Town of Brunswick

Committee:	Staff Review Committee		
Date of Meeting:	12/10/2025	Time:	10:00 AM
Minutes Prepared By:	Susan Karnes, Administrative Floater	Location:	Town Hall, Council Chambers / Zoom
1. Purpose of Meeting (<i>Weekly meeting, Training, Workshop, etc....</i>)			
Weekly meeting

3. Meeting Agenda
<p>1. Case No. 25-059 – MaineHealth Mid Coast Cancer Center Renovation: The Staff Review Committee will review and make a recommendation to the Planning Board on a Site Plan Amendment application submitted by Pine Tree Engineering on behalf of the property owner, Mid Coast Health Services, for two one-story additions and the renovation of the existing building and parking area. The subject property is located at 81 Medical Center Drive (Map 45, Lot 32, 32-1) and within the Growth Mixed-Use 8 (GM8) Zoning District, and the Shoreland Protection Overlay (SPO), Shoreland Protection Overlay – Stream Protection (SPO-SP), Shoreland Protection Overlay – Resource Protection (SPO-RP), Rural Protection Stormwater Management Overlay (RPSMO), Flood Protection Overlay (FPO), Wetland Protection Overlay (WPO), and Cook’s Corner Overlay (CCO) subdistricts. The proposed location of developmen

SHEET TITLE AND NUMBER:
A4.01
ELEVATIONS-
EXTERIOR- BUILDING

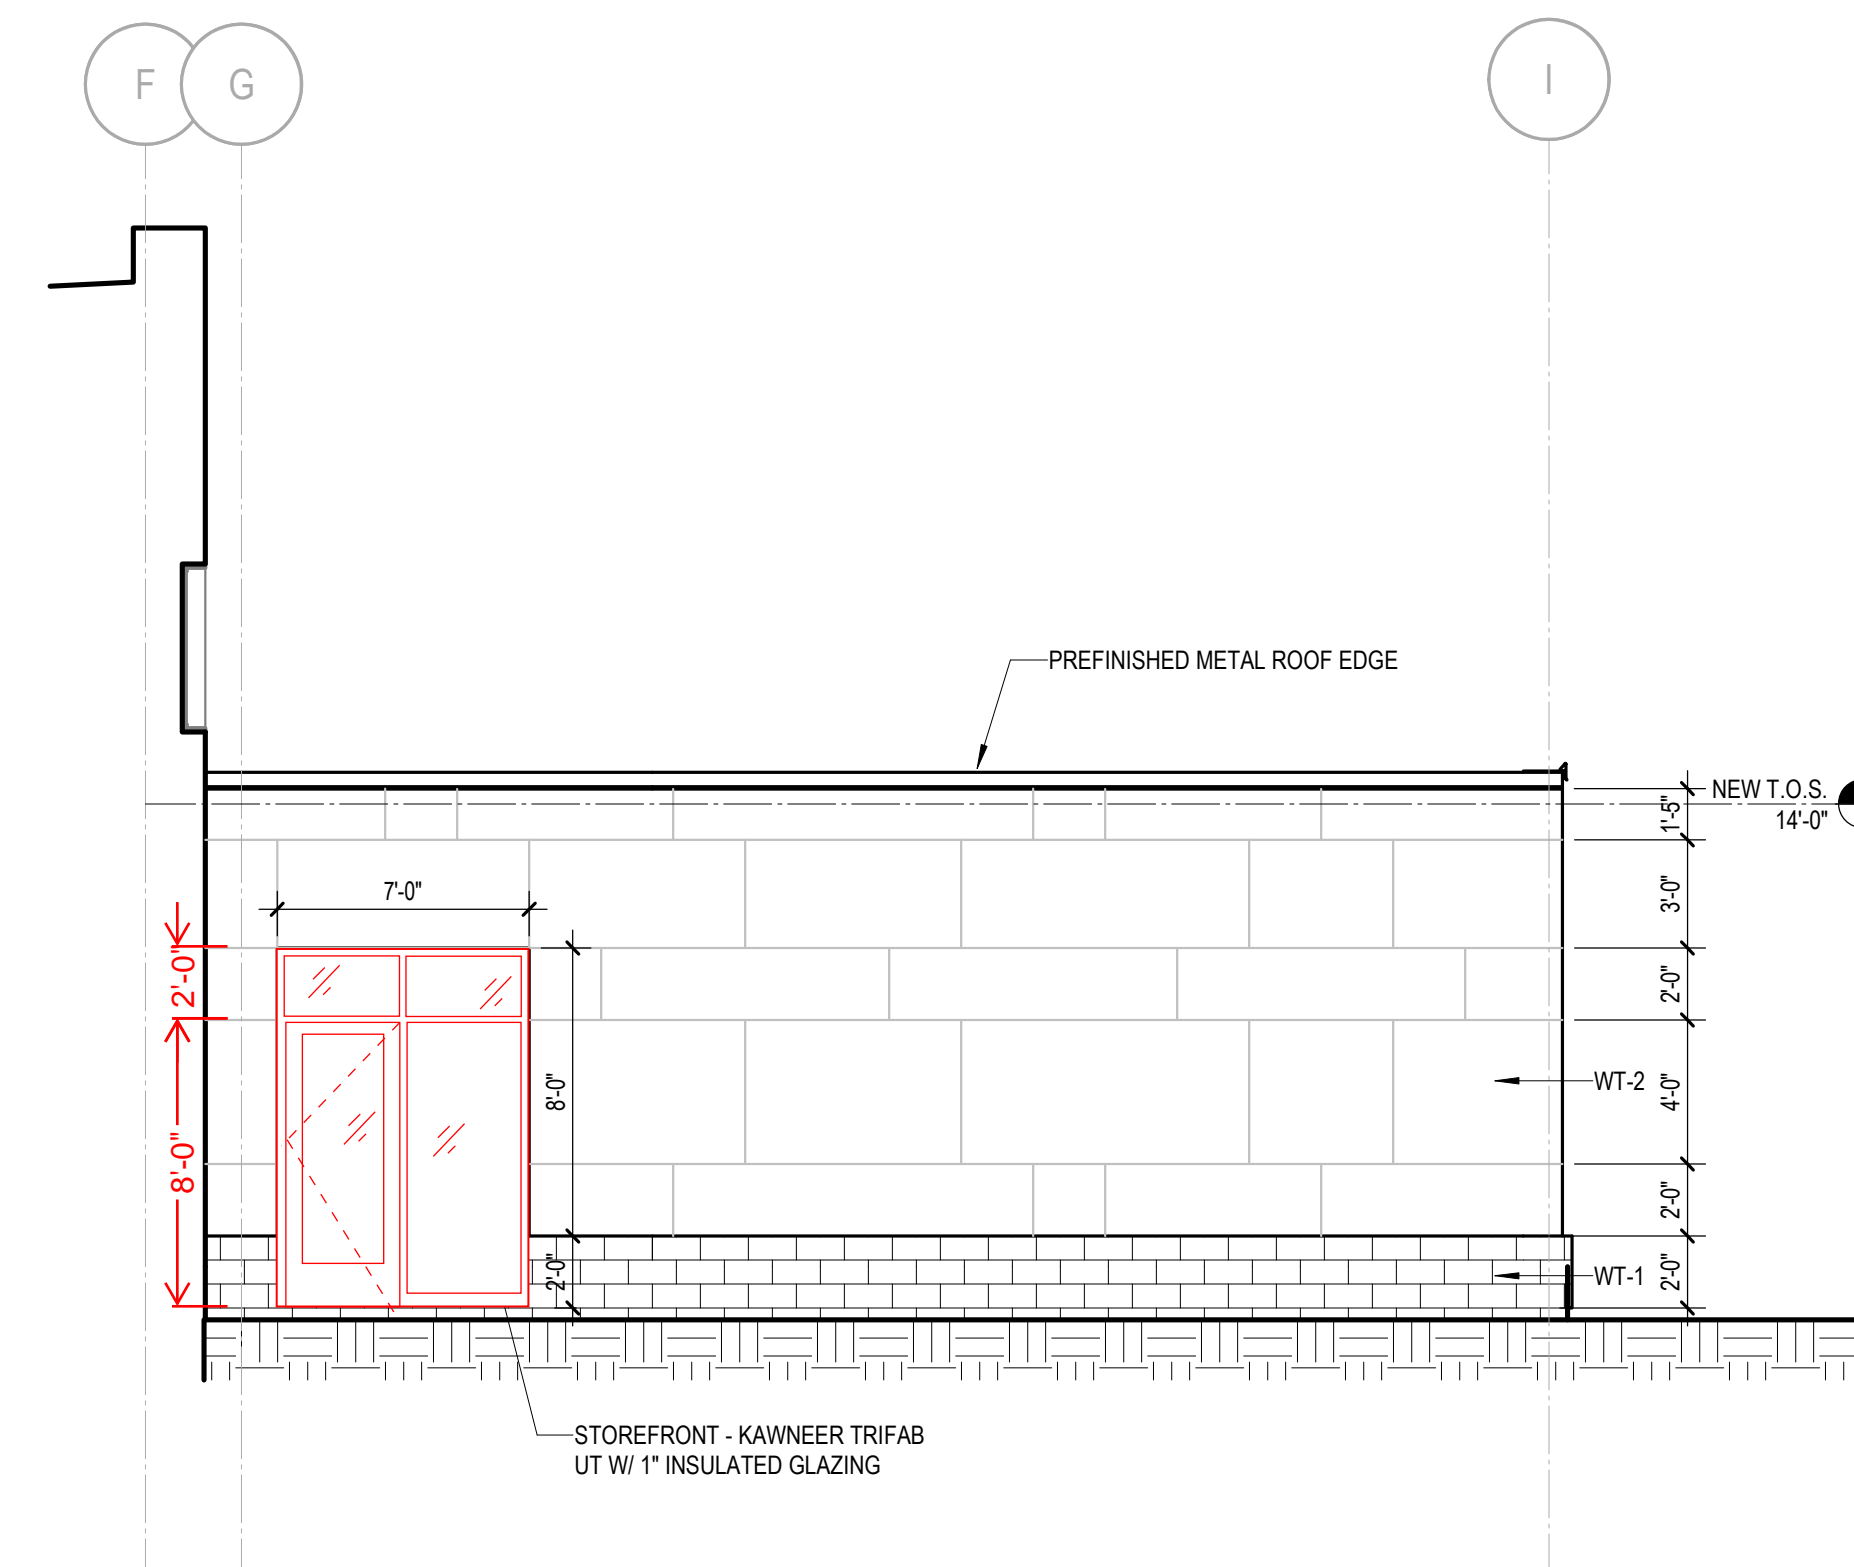
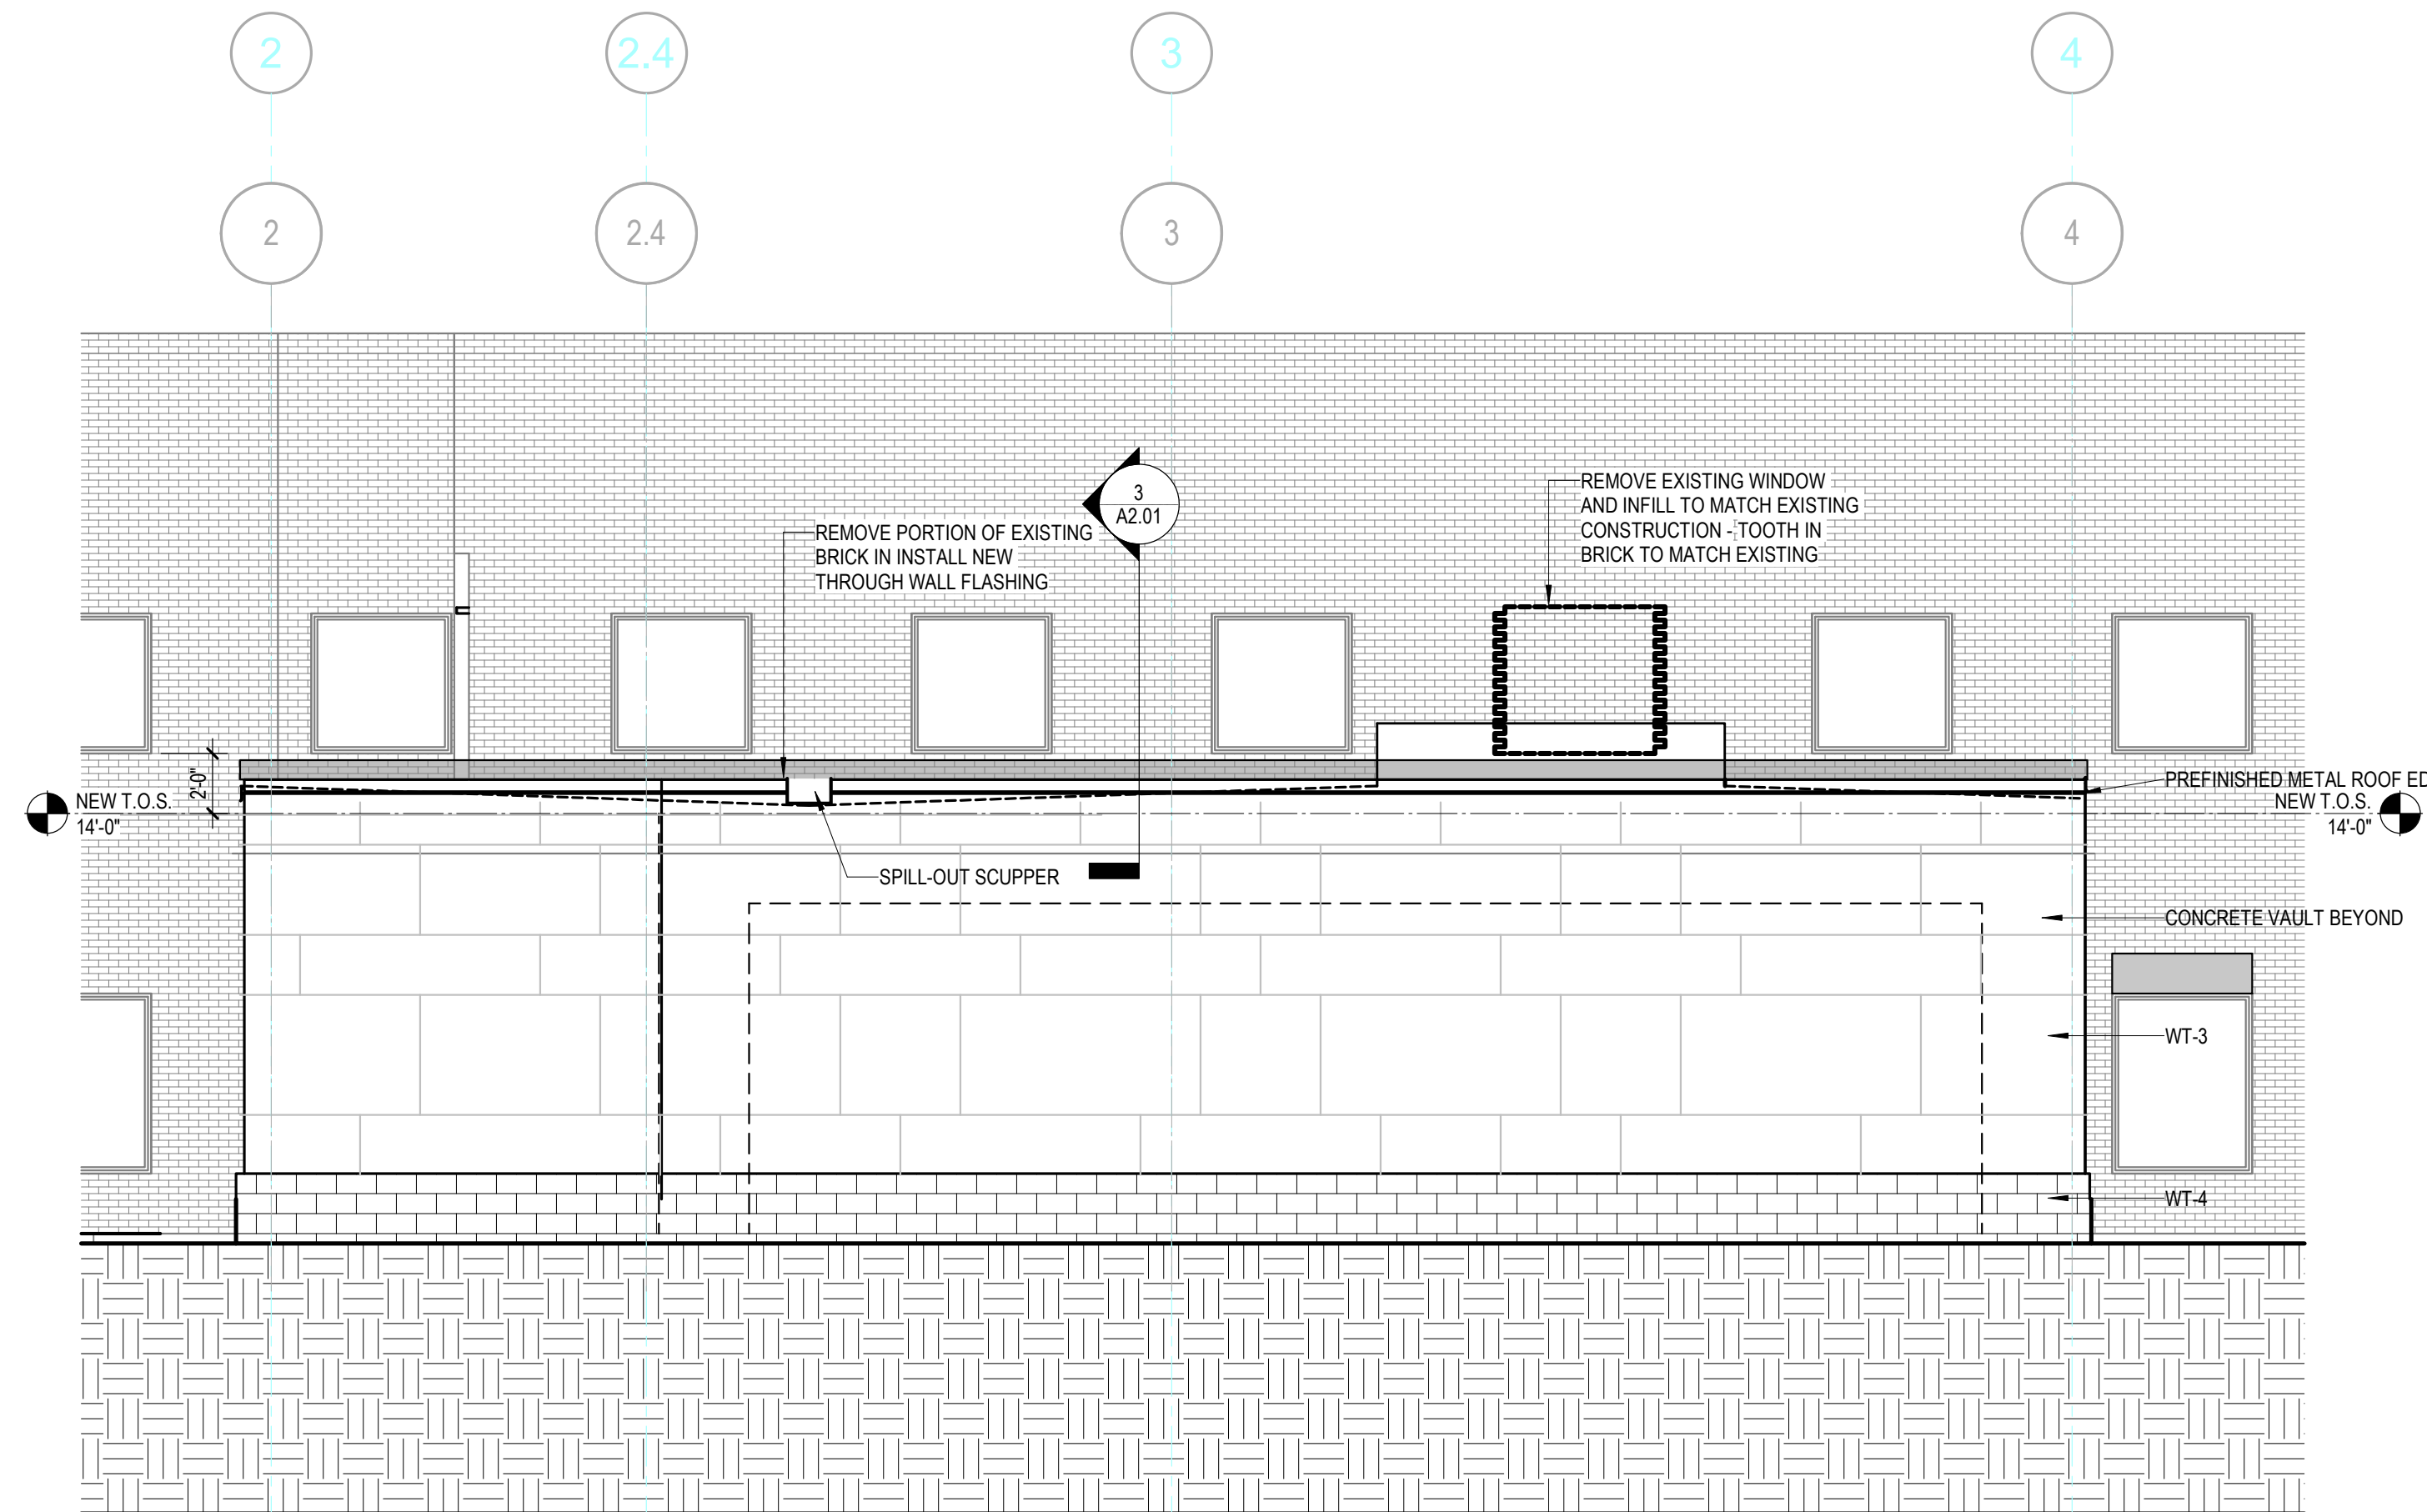
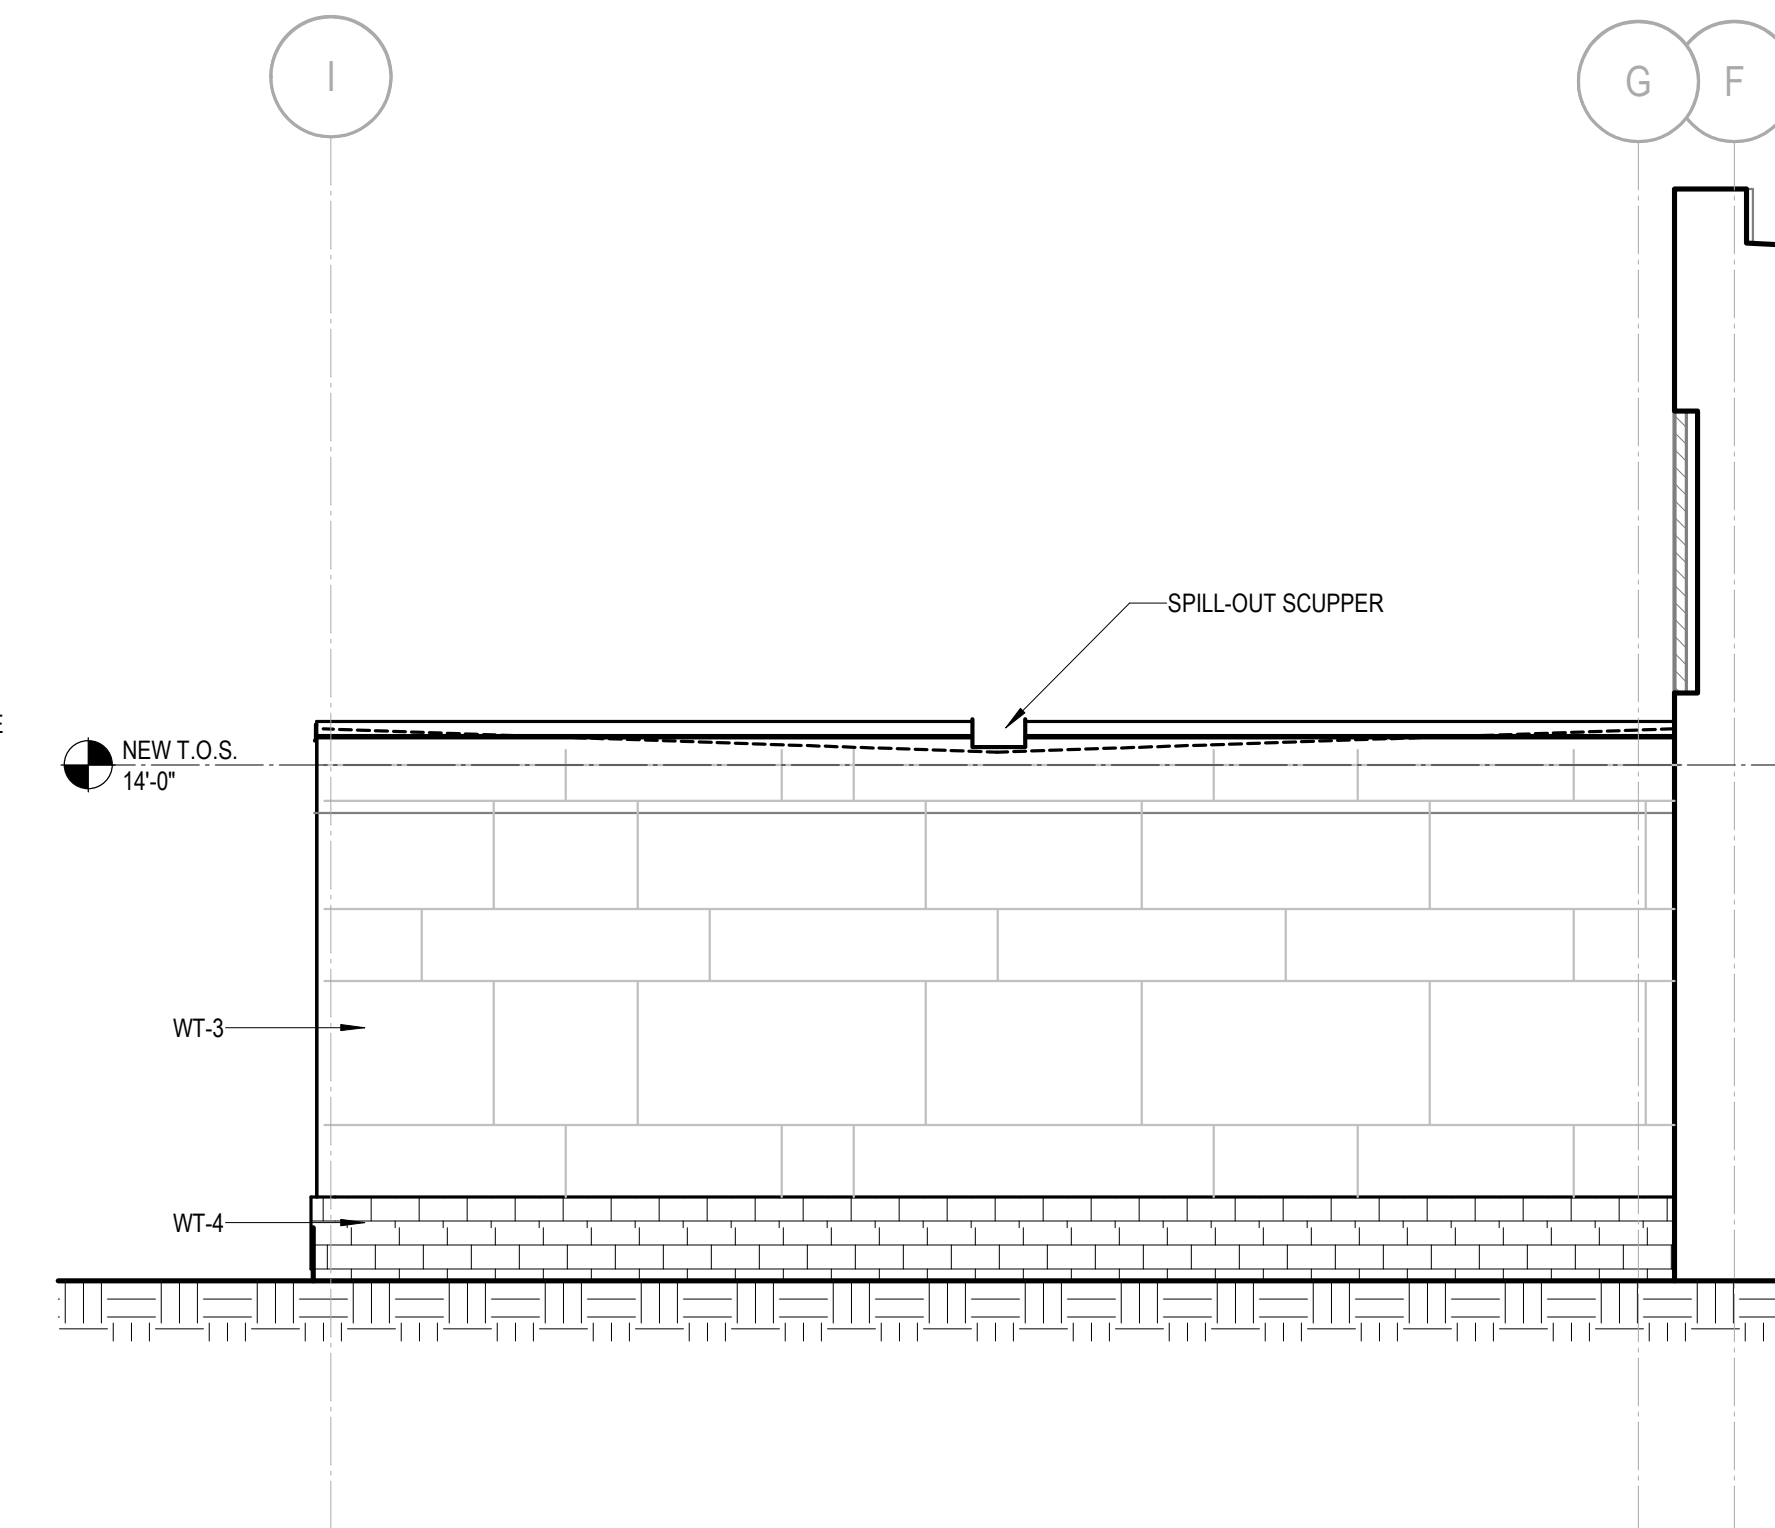
Chrissy Adamowicz: Did you have a chance to look at the Cook's Corner design standards when you were developing this? Because they do apply. And we reviewed Section 3.4, where it talks about the facade requirements and it doesn't quite meet the requirements. The requirements ask for windows and a broken-up facade. And we were looking at it and we understand that it's not like a really very public facing building. It's not like the full building, but it does apply to additions. But had you considered windows in any parts of the buildings and also maybe vegetation to break it up? The standards talk about a variety of ways to break it up.

3.4 J Windowless circumstances says, "buildings without windows, i.e. a computer, a server building or self-storage buildings, shall incorporate a change in scale and siding materials instead of windows to create a sense of rhythm and cadence to create human scale. These material scale changes shall be demonstrably compatible with the scale and cadence of adjacent building facade treatments". The LINAC part of the building is towards the back, but the pharmacy faces a parking lot, so that is a little bit human facing.

3. Add ornamental grass along parking lot side of pharmacy, near bollards	See Section B-B on AS3.00 Civil Details
Architecture Comments	
4. Review Cooks Corner Design Standards, specifically Section 3.4 Façade Requirements, and within 3.4.j.	See Exhibit 8: Cook's Corner Design Standards Narrative.
Engineering Comments

The two additions to 81 medical center drive are secondary facades according to the definition in Section 3.4 Façade Requirements item C.

The design of these additions take into account the scale, materials and colors of the existing building, by complementing these colors and materials rather than attempting to copy directly as it is difficult to match brick and precast that have weathered for 18 years.
